CHRISTOPHER WILLIAMS ARCHITECTS LLC

ADDENDUM NO. 2

Date: November 2, 2022

Project: **SSF-2018-01 GNHWPCA COLLECTIONS MAINTENANCE FACILITY**

A5 O.H. DOOR HEAD
3" = 1'-0"

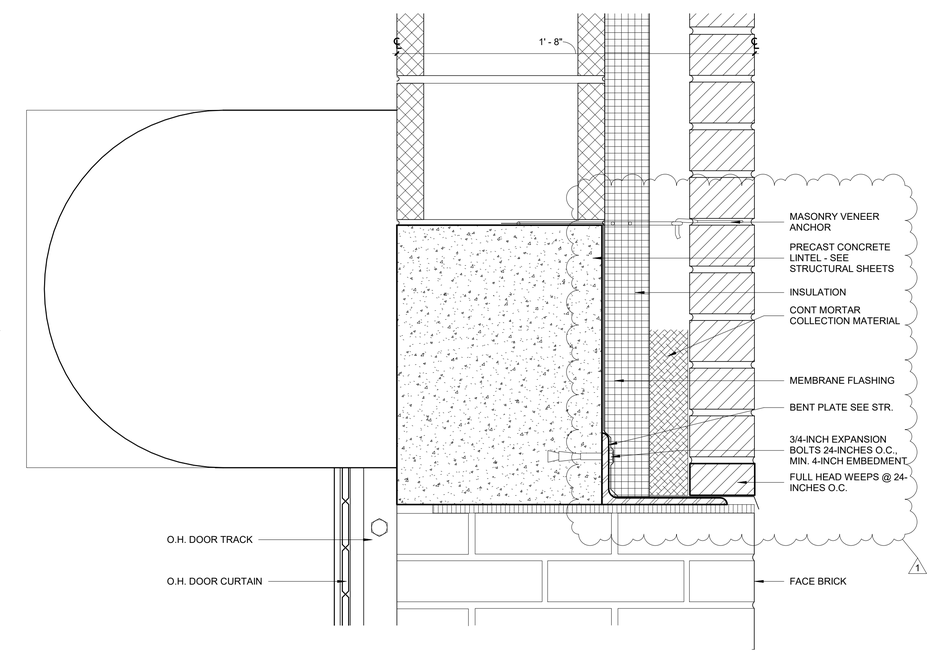
Sheet A601: SCHEDULES
A5: UPDATED INSULATION, MORTAR COLLECTION & WEEPS
B3: UPDATED MASONRY ANCHORS
B2: UPDATED DOOR JAMB DETAIL
DOOR SCHEDULE: UPDATED DETAIL LOCATION
